**RE: National Construction Code (NCC) 2022 Volume One Section J
Part J4 Building Fabric Statement of Compliance**

JOB NO.: 230339

REV. NO.: REV A

SUBJECT PREMISE: Castlecove Redevelopment (Clubhouse) | 68 Deepwater Road, Castle Cove NSW 2069

DRAWING NO.
DA 3.11
SCALE
As indicated
0m 2 4 5m
Scale 1:250

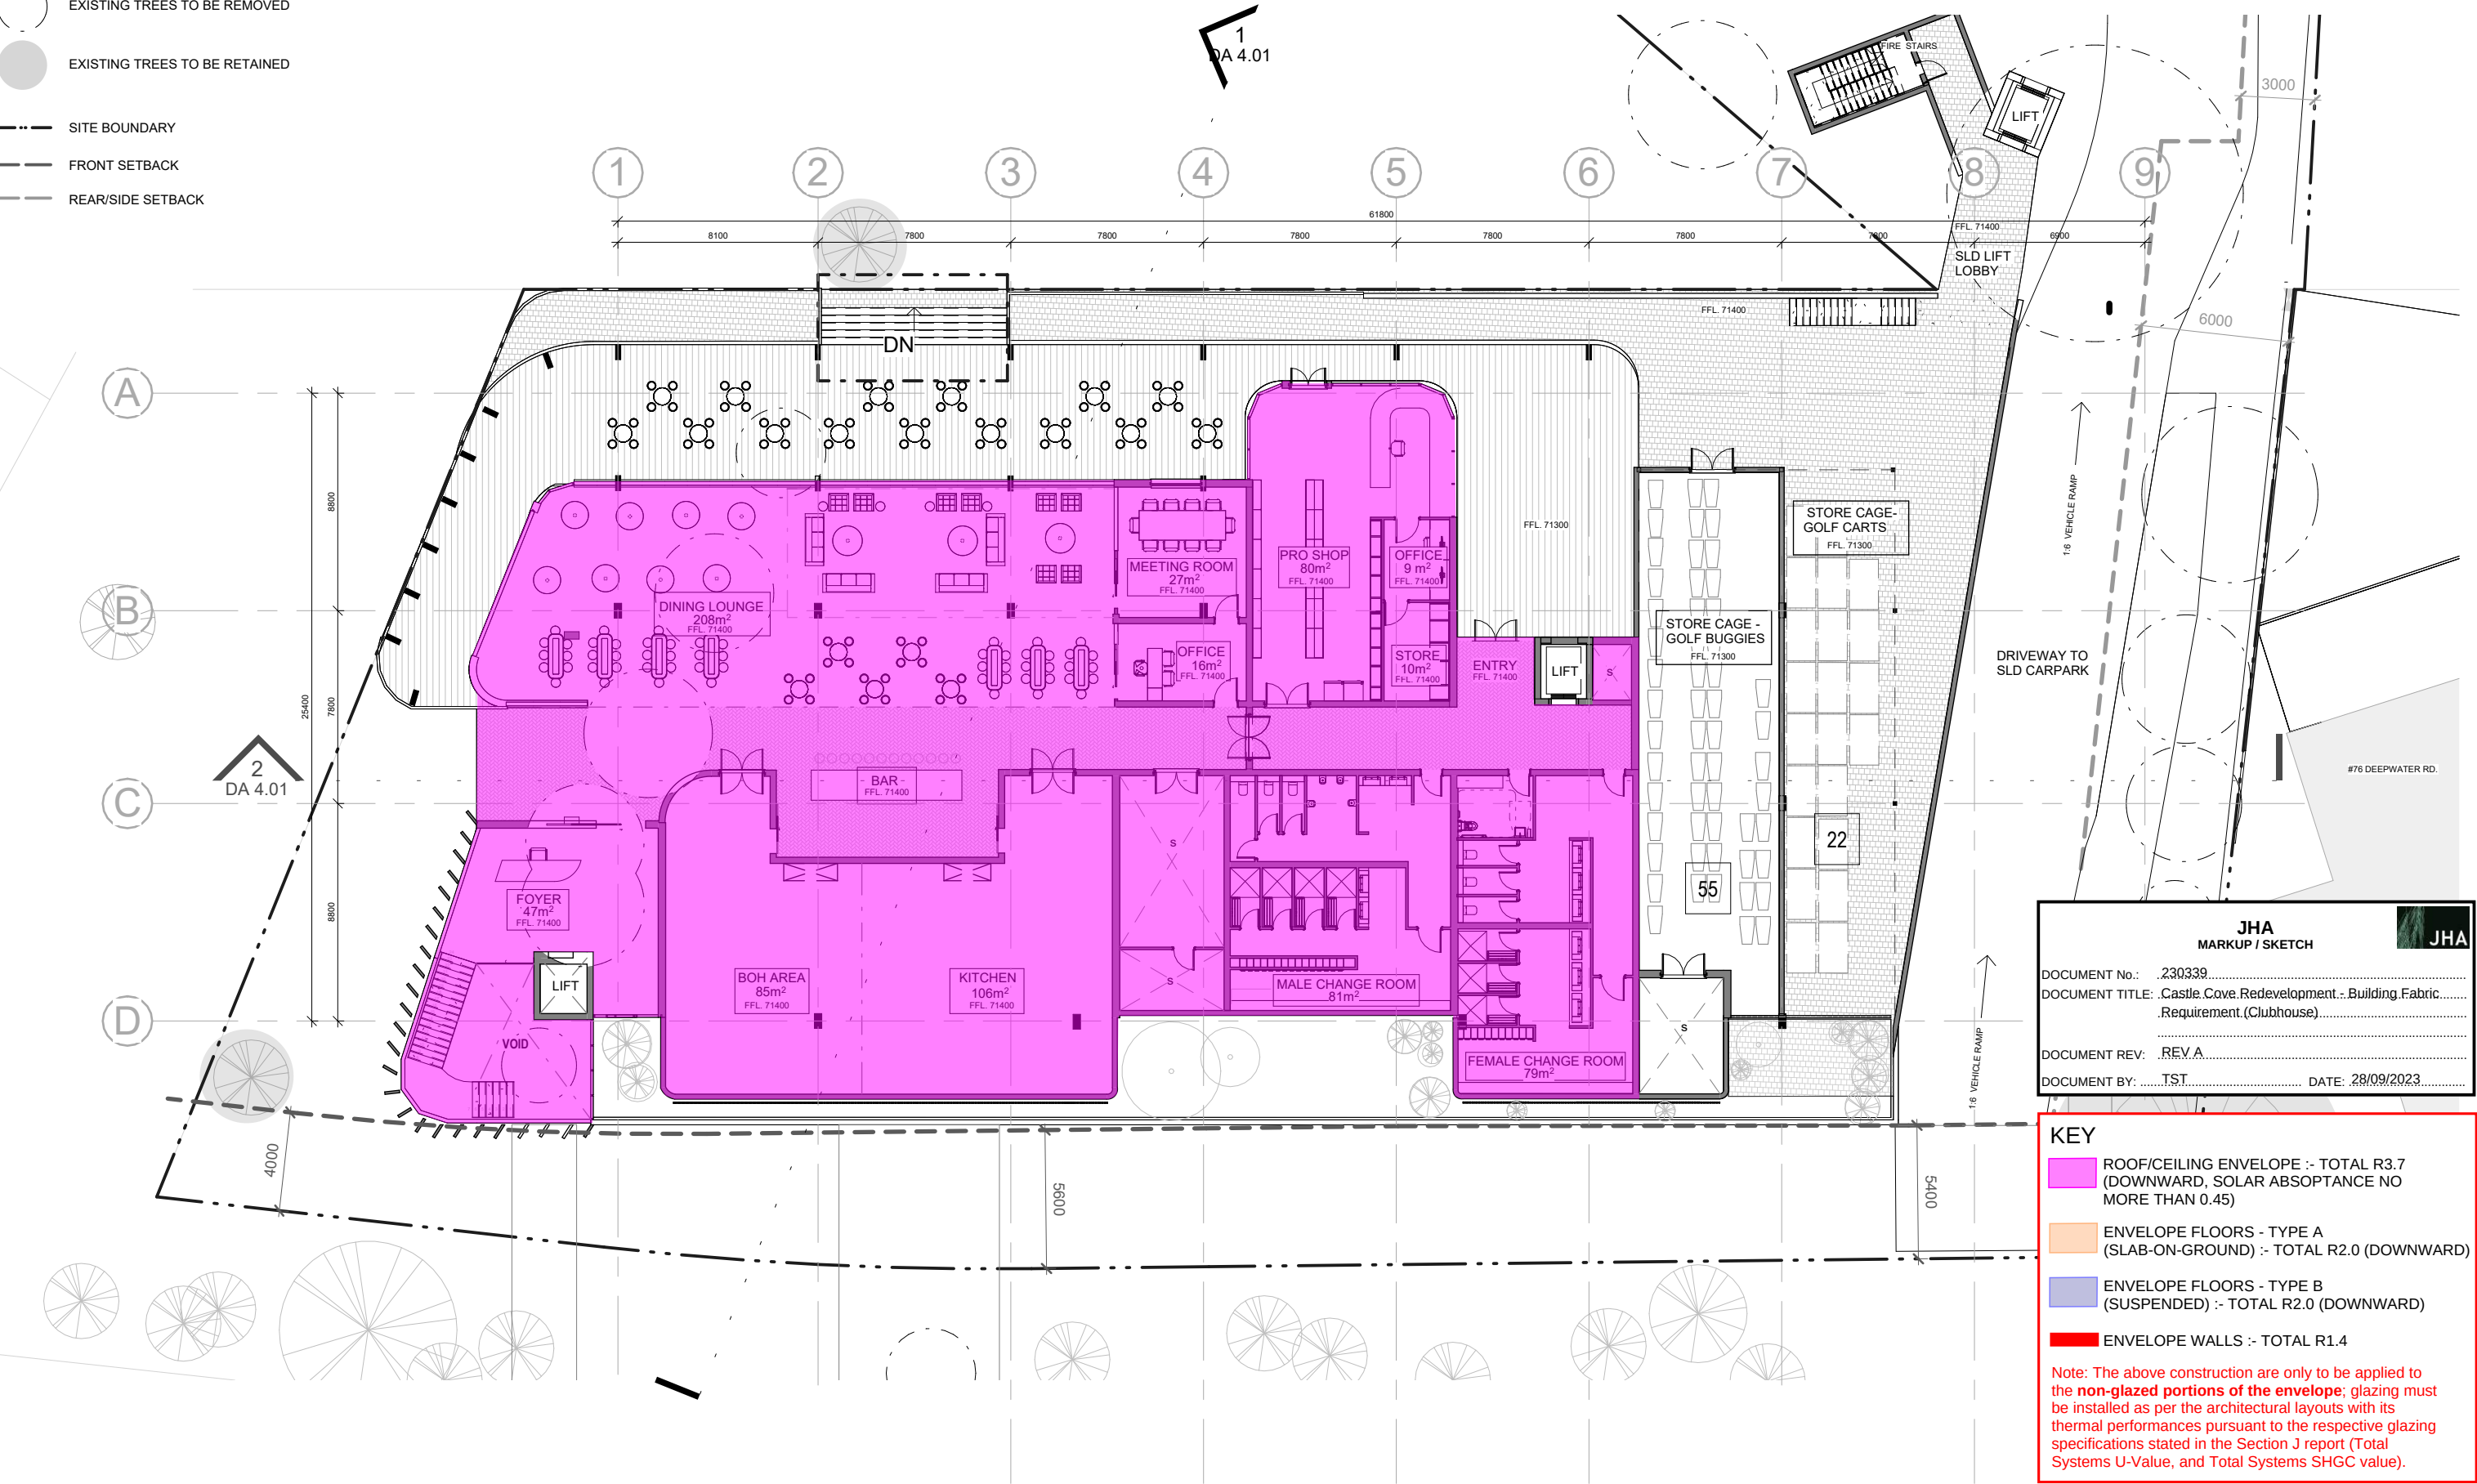
JHA
MARKUP / SKETCH

ROOF/CEILING ENVELOPE :- TOTAL R3.7 (DOWNWARD, SOLAR ABSOPTANCE NO MORE THAN 0.45)

ENVELOPE FLOORS - TYPE A (SLAB-ON-GROUND) :- TOTAL R2.0 (DOWNWARD)

ENVELOPE FLOORS - TYPE B (SUSPENDED) :- TOTAL R2.0 (DOWNWARD)

ENVELOPE WALLS :- TOTAL R1.4

Note: The above construction are only to be applied to the non-glazed portions of the envelope; glazing must be installed as per the architectural layouts with its thermal performances pursuant to the respective glazing specifications stated in the Section J report (Total Systems U-Value, and Total Systems SHGC value).
